CRUISER  
AIRCRAFT

No.: SB-SC-054

# SERVICE BULLETIN

<b>MODEL AFFECTED:</b>	SportCruiser / PiperSport operating outside EASA rules
<b>SUBJECT:</b>	Replacement of the original SG0030L/P main landing gear legs by the reinforced SG0160L/P variant
<b>AIRCRAFT AFFECTED:</b>	All SportCruiser / PiperSport
<b>COMPLIANCE:</b>	Apply this Service Bulletin, when replacement of the original SG0030L/P main landing gear legs is required

Fig. 1: Main landing gear leg

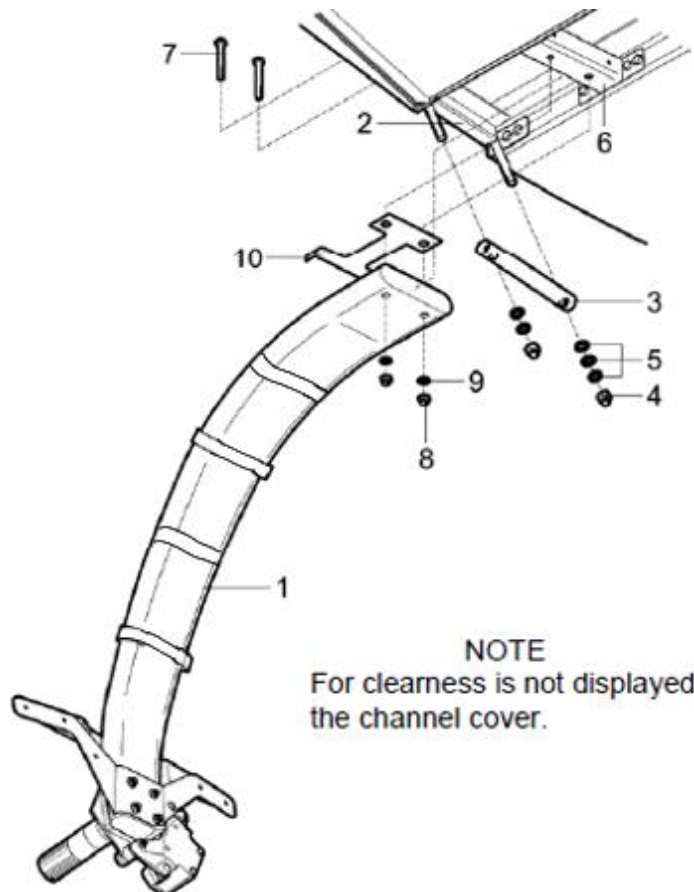
**NOTE:** This Service Bulletin is valid for both sides (left side shown).

**NOTE:** Securing bolts (2) and (7): Use only as many washers (9, Fig. 1) so that when the locknut (4, 8) is tightened, the bolt thread should protrude throughout the locknut not less than 1,5 pitches beyond the top of the nut or plastic insert (see SAE ARP1515 or other aviation standards).

Fig. 2: Main gear leg installation (illustrative sketch)

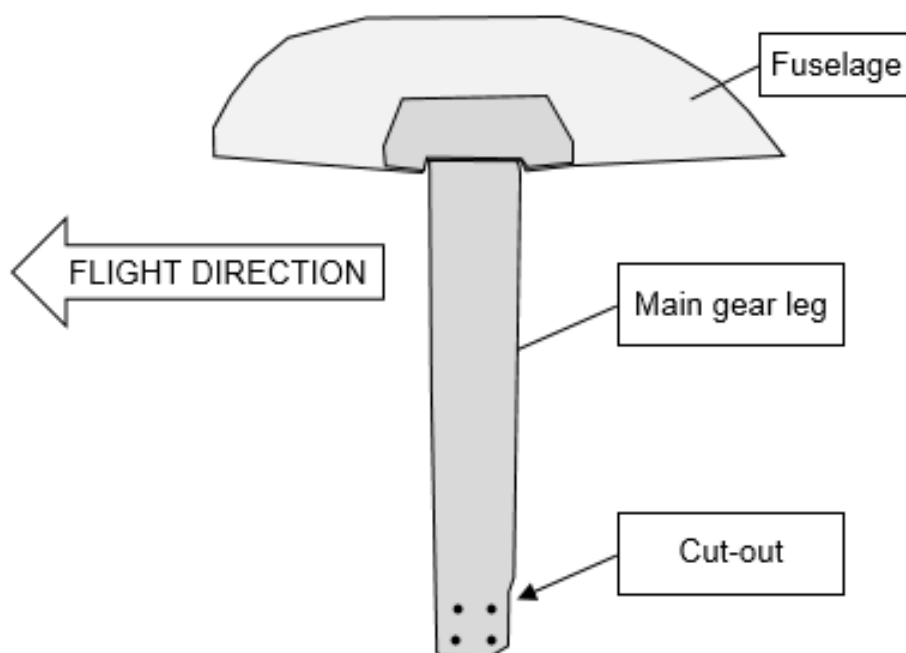
**WARNING: IT IS NOT ALLOWED TO MIX THE ORIGINAL SG0030L/P AND THE REINFORCED SG0160L/P MAIN GEAR LEGS! BOTH THE LEFT AND THE RIGHT LEG MUST BE ALWAYS OF THE SAME TYPE.**

- 3) Install the reinforced main landing gear legs, see the SC-AMM-1-0-00, Chapter 8, latest revision.
- 4) Be careful of correct position according to the flight direction. The leg has to be installed so that the cut out on the leg bottom part must be on the rear side, see Fig. 2 above.
- 5) When the leg is inserted/pushed into the final position, drill two holes  $\varnothing$  8 mm for bolts (7, Fig. 1) in the main landing gear attachment (2) and spacer (10).
- 6) Install the wheels assembly, see the SC-AMM-1-0-00, Chapter 8, latest revision.

Fig. 3: Main gear leg zip tie position

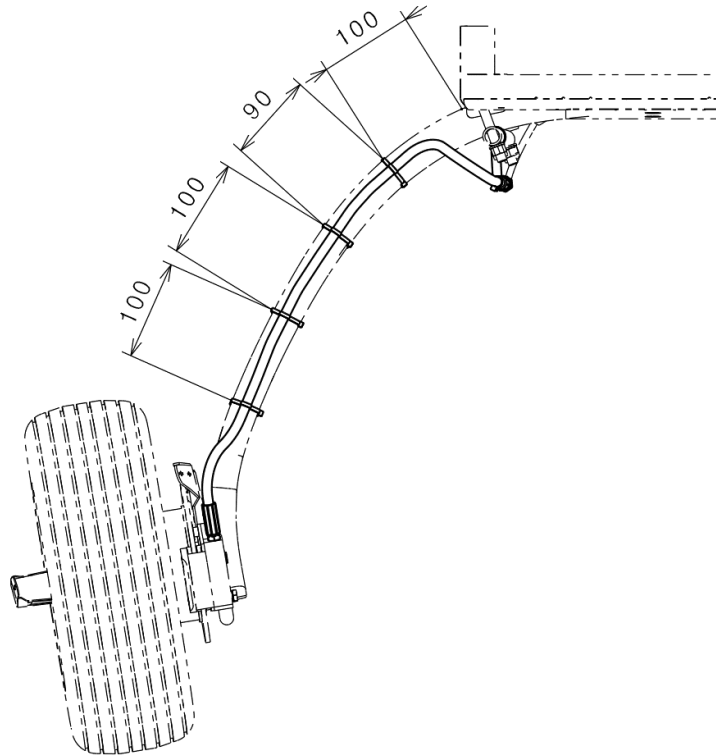
- 9) Adjust the brake hose as shown (Fig. 3).  
10) Secure the position of the zip ties with glue (013/014).
